***MODIFICATION REQUEST TO CONCEPT APPROVAL  
AND STATE SIGNIFICANT DEVELOPMENT  
ASSESSMENT REPORT:***

**Concept Approval MOD 11  
SSD Application for Block 11**

**Central Park (former Carlton United Breweries site)**

**MP 06\_0171 MOD 11 and SSD 6376**

**Figure 7: Comparison between the building envelope layout of the Concept Approval (top) and proposal (bottom) (Base source: proponent's application and MP06\_0171 MOD10)**

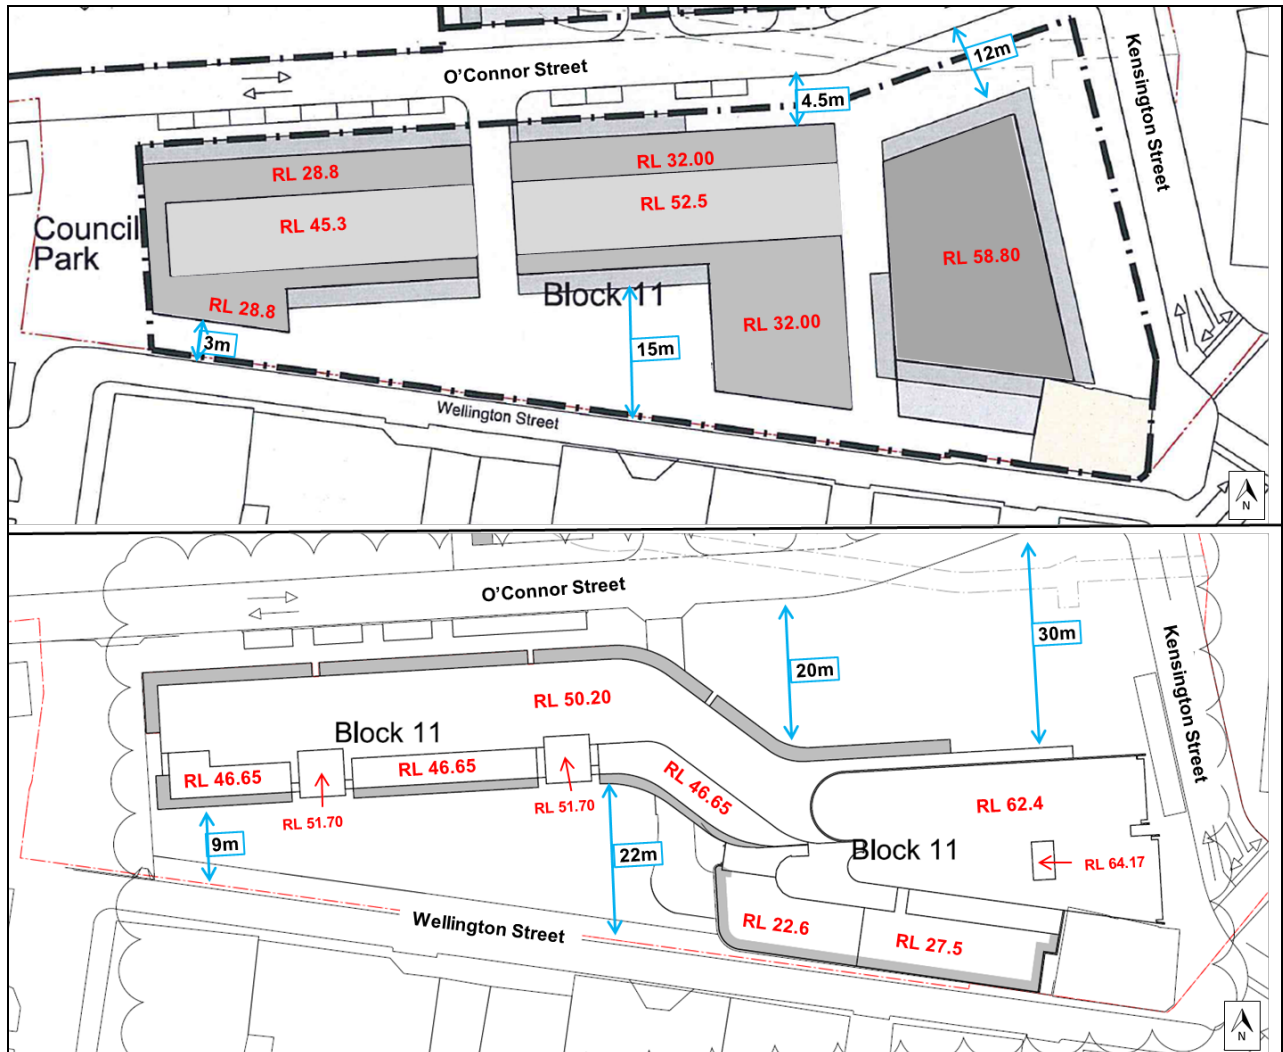
The majority of public submissions (90%) raised concerns about the height and bulk of the proposed building envelope. In addition, 78% of public submissions raised specific concern that the proposed height exceeds the Carlton United Brewery Expert Advisory Panel recommendation that buildings on the southern boundary should be a maximum of 15 metres in height to relate to the warehouses and adjacent buildings in Chippendale. The Department notes that the Expert Advisory Panel recommendation for a maximum height of 15 metres along the southern boundary to Wellington Street was incorporated into the Concept Approval in 2007. However, in the determination of Modification 2, the Department determined that a revised building form for Block 11 with a height of 4 to 11 storeys was acceptable and that a maximum height of 15 metres along the southern boundary was no longer required.

The Department considers that when compared to the Concept Approval the proposed modifications will provide for a more slender building envelope and more generous setbacks. The increase in the maximum building height (being 4.9 metres to the west and 5.37 metres to the east) will maintain an appropriate built form transition between Block 5C to the north and the existing low-rise buildings to the south and will also be offset by the increase in building setbacks and open space provision. In addition, proposed amendments to building envelopes are acceptable as:

The proposed modifications to the building envelope includes filling in the gaps between the buildings, relocating the western edge of the building envelope further away from Wellington Street and a minor increase in the height of the building envelope (**Figure 7**).

Figure 10: The approved (top) and proposed (bottom) location of the car parking spaces immediately adjacent to the site (Base source: MP06\_0171 MOD10 and applicant's RtS)

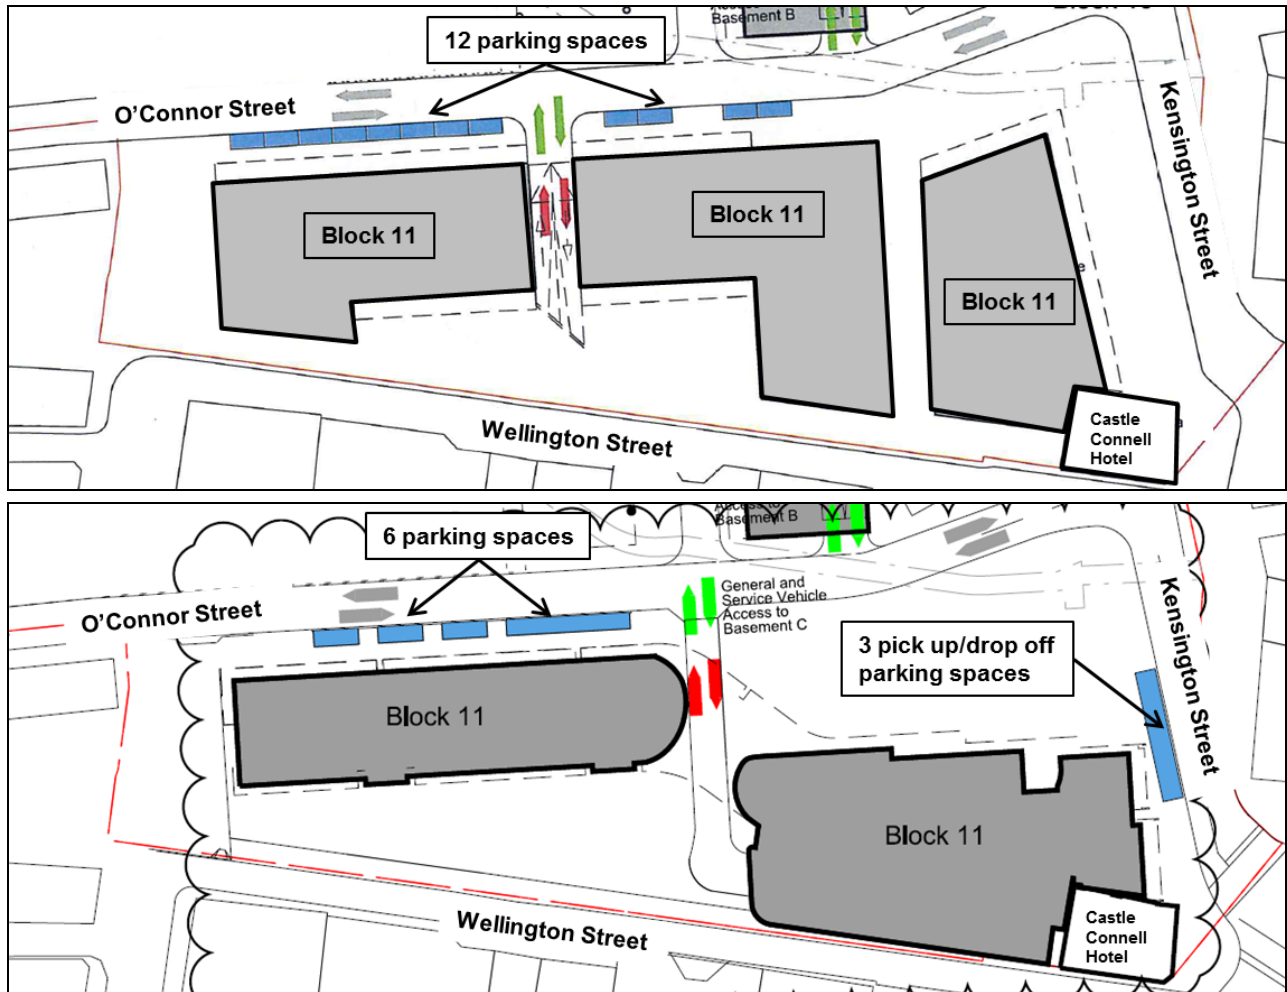
The proposal includes the reduction of six car parking spaces on O'Connor Street (from 12 to 6) and the addition of three pick up/drop off car parking spaces on Kensington Street for the childcare facility, which equates to an overall reduction of three on-street car parking spaces (refer to **Figure 10**).

In light of the above assessment, the Department is satisfied that the proposed development provides sufficient on-street car parking spaces despite the reduction of three on-street car parking spaces.

Figure 11: Typical floor layout and building depth (Base source: applicant's RtS)

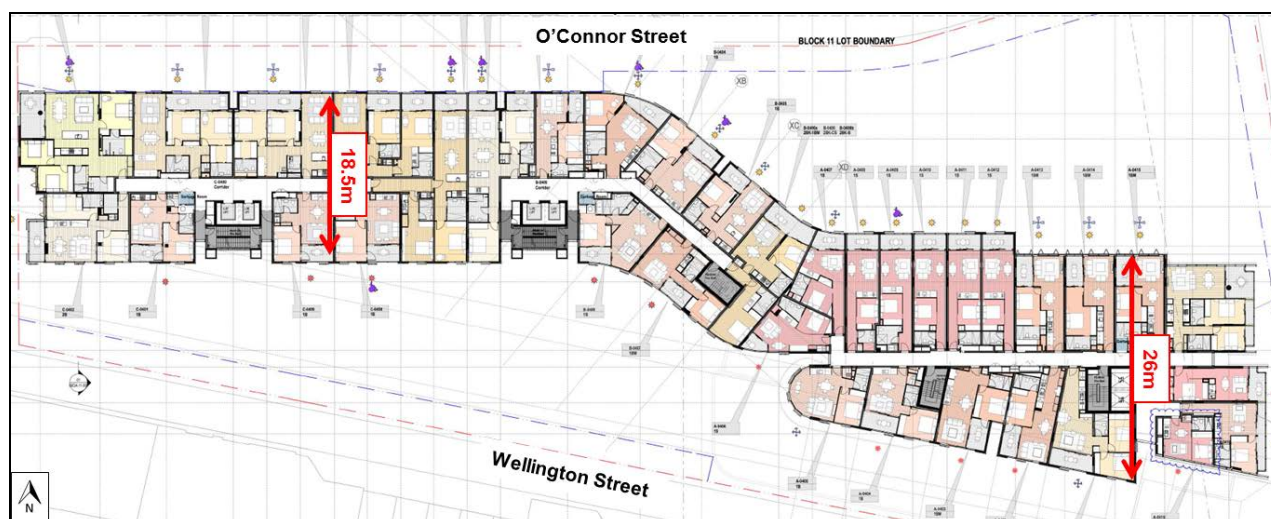
The RFDC recommends that building depth should be no greater than 18 metres, while the ADC recommends that overall building depth should not exceed 12 - 18 metres. The typical building depth of the proposal varies from between 18.5 metres and 26 metres (**Figure 11**), although the building depth on level 1 and the upper levels (levels 9-13) are considerably less than 18 metres.

Notwithstanding the proposed building depth range, the Department is of the view that the residential apartments will be afforded a high standard of residential amenity, as:

**Figure 12: Hybrid cross ventilation strategy (Source: applicant's RtS)**

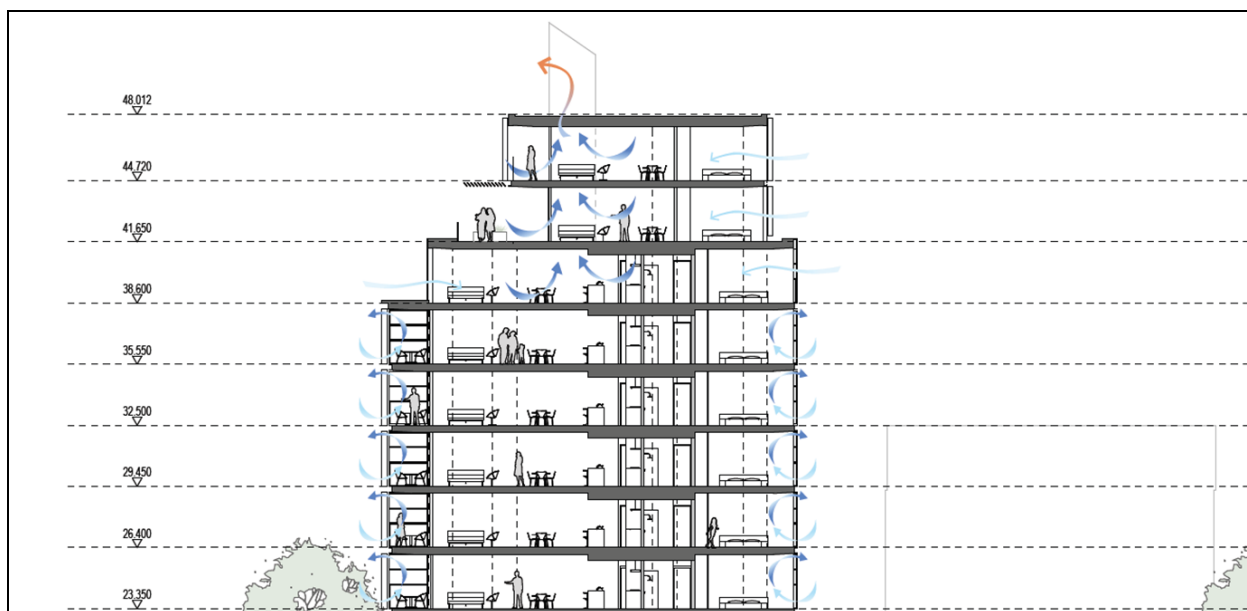
The applicant has confirmed that up to 70 apartments (24%) that do not achieve natural cross ventilation will be afforded 'hybrid cross ventilation'. In this regard, the proposal includes assisted ventilation risers which provide a direct connection to vertical fresh air shafts via fire isolated and acoustically treated ducts (refer to **Figure 12**).

The Department considers that the proposed level of ventilation is acceptable as:

**Figure 15: Proposed O'Connor Street park layout (Base source: applicant's RtS)**

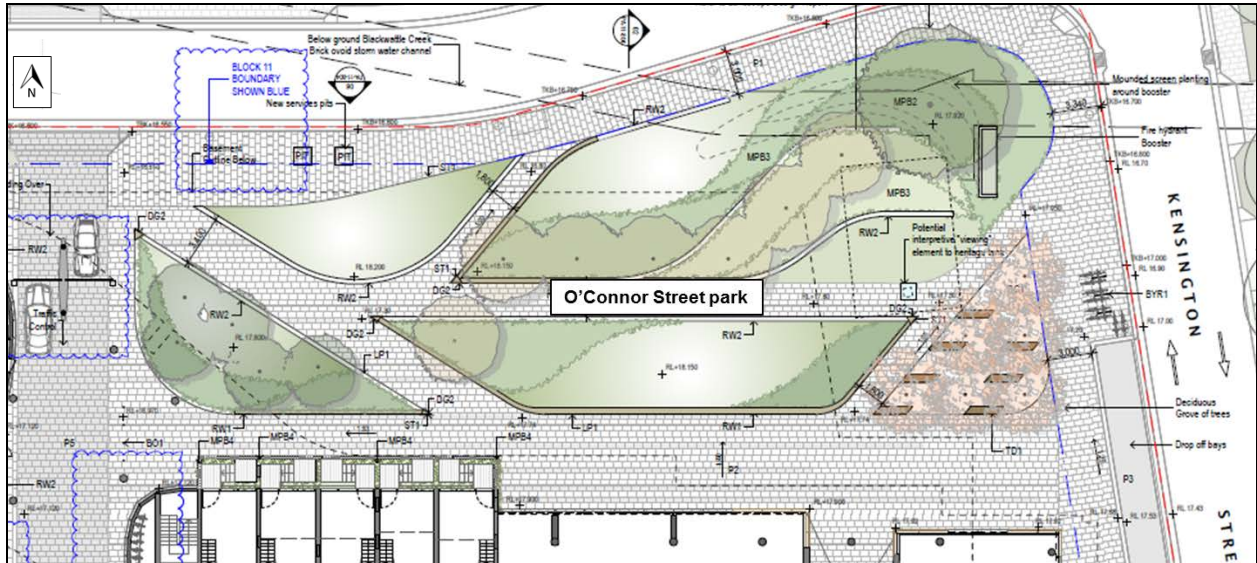
The applicant has stated that the O'Connor Street park has been designed to provide a range of spaces that connect with the proposed retail units and provide a buffer to Kensington Street. The park has also been designed to encourage passive recreation and provide a pleasant visual outlook for the retail units (refer to **Figure 15**).

The Department notes that the proposed park would be overlooked/activated along its southern side at ground floor level by new retail units and also residential apartments. A broad paved area (approximately seven metres) is provided outside the retail units and the main pedestrian pathways through the park will be 3.4 metres wide. In light of these attributes, the Department considers that the proposed design of the park would be suitably civic in nature. The Department also considers that sufficient planted areas are provided to ensure that the park is not overly urban in nature and visually softens this prominent corner.

**Figure 16: Proposed Wellington Street park layout (Base source: applicant's RtS)**

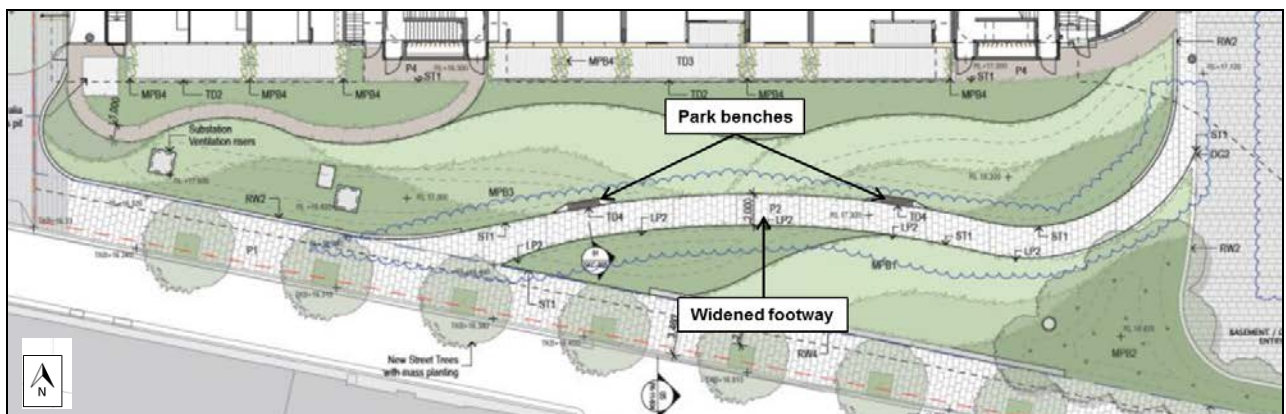
In response to Council's comments the applicant has included an additional 2 park benches and widened the pedestrian pathways from 1.5 to 2 metres, as shown on **Figure 16**.

The Department considers that the widening of the main pathway of the Wellington Street park and inclusion of park benches represent positive alterations, which will foster additional active recreation opportunities. In addition, given the nature and close proximity of Chippendale Green to the site, the Department does not consider it necessary that the majority use of Wellington Street park need be for active recreation.

The Department concurs with Council that the mounded elements of the park should not provide places of concealment or provide opportunities for anti-social behaviour. The Department therefore recommends a condition requiring the park to be designed in accordance with the principles of Crime Prevention Through Environmental Design (CPTED). The Department is therefore satisfied that the Wellington Street park is acceptable, subject to the requirements of the condition noted.

**Figure 17: The proposed location of the widened footway and cantilevered first floor level (Source: applicant's RtS)**

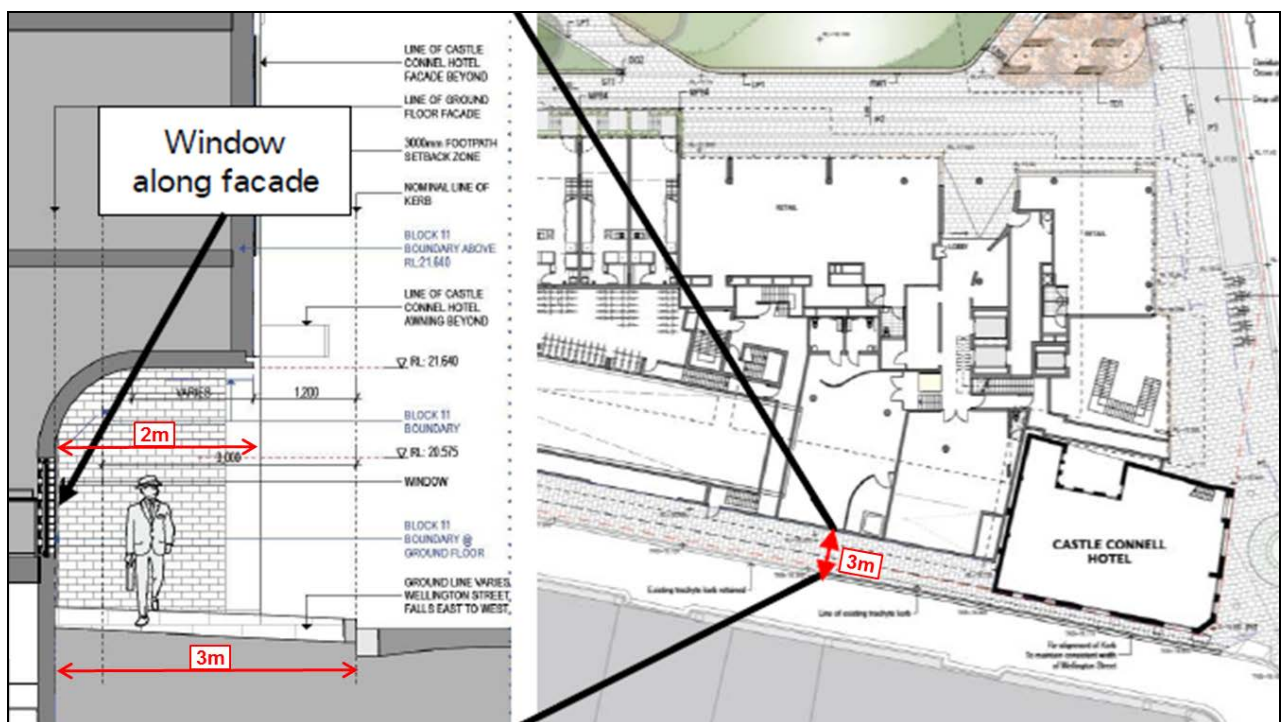
The eastern portion of the building (to the rear of the Castle Connell Hotel) is proposed to be cantilevered over the footway at first floor level, for two metres (refer to **Figure 17**).

Council has stated that it does not support the encroachment above land to be dedicated and therefore recommends that the building be set back to remove the overhanging element.

The Department supports the provision of a three metre wide publicly accessible footway along the northern side of Wellington Street. The footway would improve pedestrian safety by separating pedestrians and vehicles and provide an appropriate threshold to the development. The Department considers that the provision of the cantilevered first floor level is acceptable subject to conditions requiring that:

**Figure 18: The original (left) and revised (right) proposed landscaping / public domain plan (Source: applicant's RtS)**

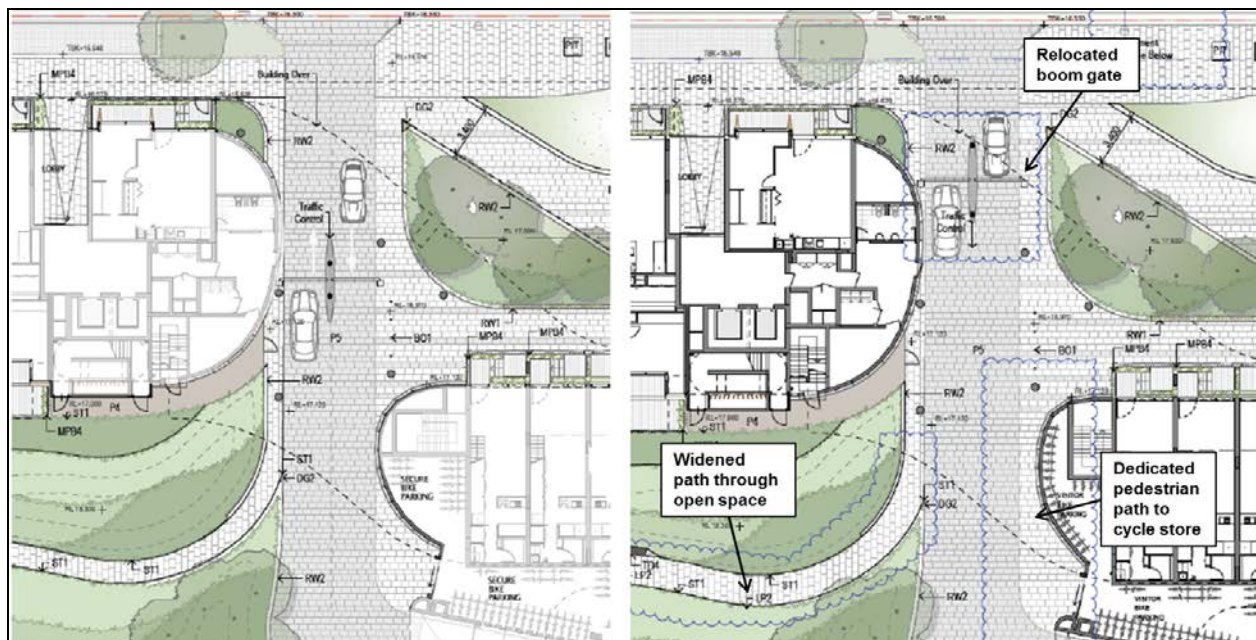
In response, the applicant has revised the proposal in the following ways, as shown in **Figure 18**:

- consistent materials are provided throughout the shared zone to indicate pedestrian priority;
- a delineated pedestrian access path is provided to the bicycle storage area;
- the traffic control point is relocated closer to O'Connor Street;
- the size of the pathway through Wellington Street park is increased.

The Department considers that the proposed changes, noted above, will ensure that pedestrian priority will be provided throughout the public domain and within the shared vehicular/pedestrian zone ensuring the creation of a safe pedestrian environment.
